R7 Network PTZ Dome Camera Firmware

Version: V5.6.12 Release Note (**External**)

(2019-07-16)

- #### 3.1.2 DS-2DE2XXX/W models newly support Stream Adaption. When you enable the function, live view fluency is taken as the priority of camera performance. The camera adjusts video-related parameters automatically, and the pre-set video-related configuration is invalid.

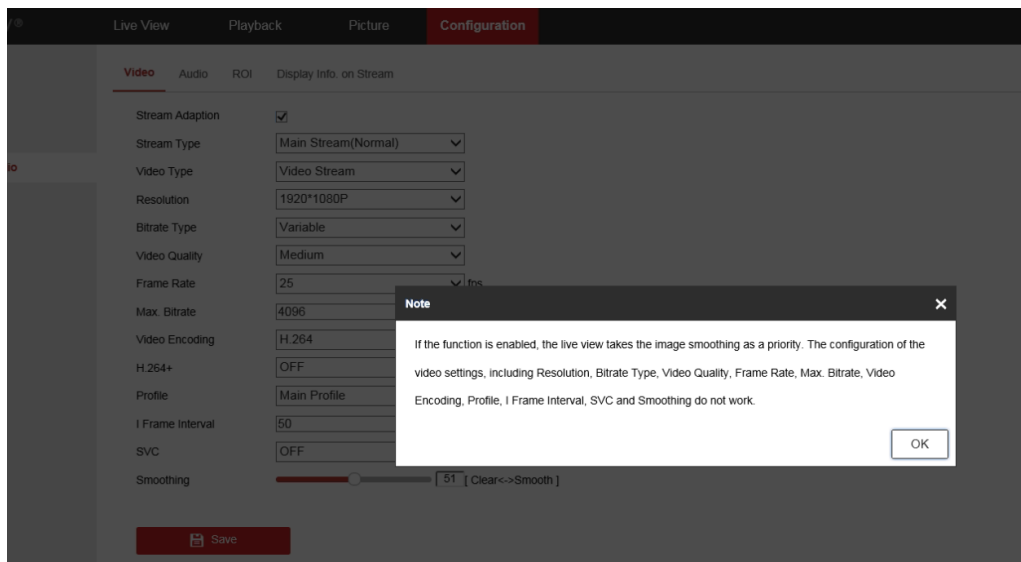
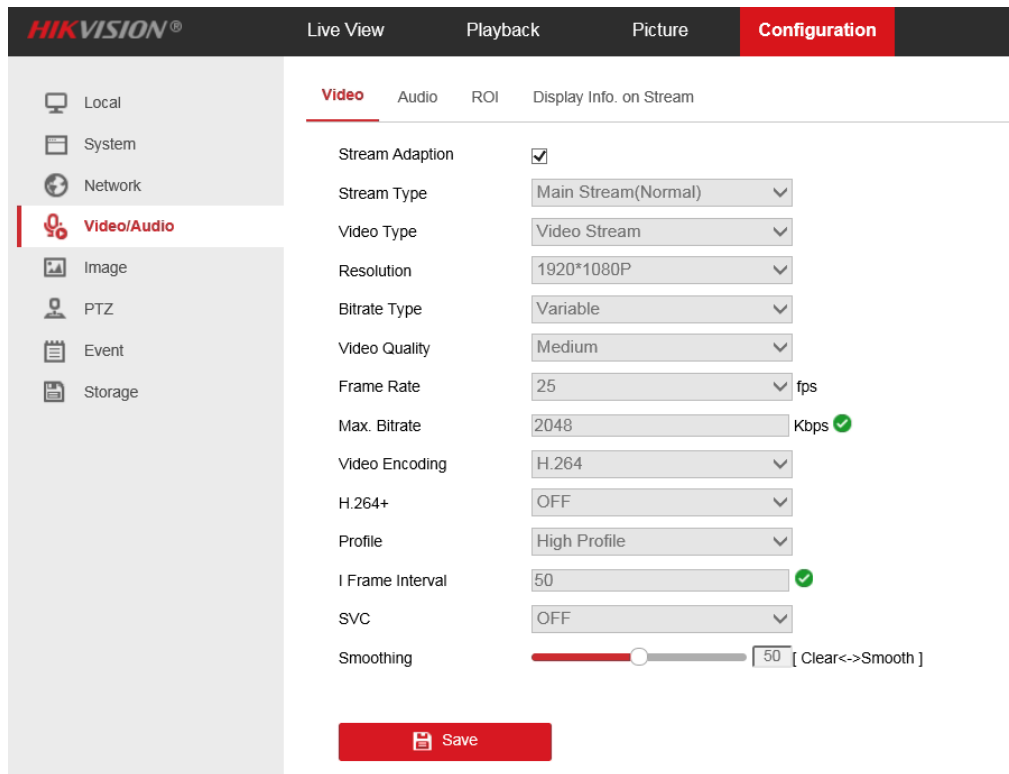
- When you enable this function, the device will display a prompt: “If the function is enabled, the live view takes the image smoothing as a priority. The configuration of the video settings, including Resolution, Bitrate Type, Video Quality, Frame Rate, Max. Bitrate, Video Encoding, Profile, I Frame Interval, SVC and Smoothing do not work”.

- It will be required to reboot the device when this function is enabling and saved. The video parameter is grayed out even if the restart is cancelled.
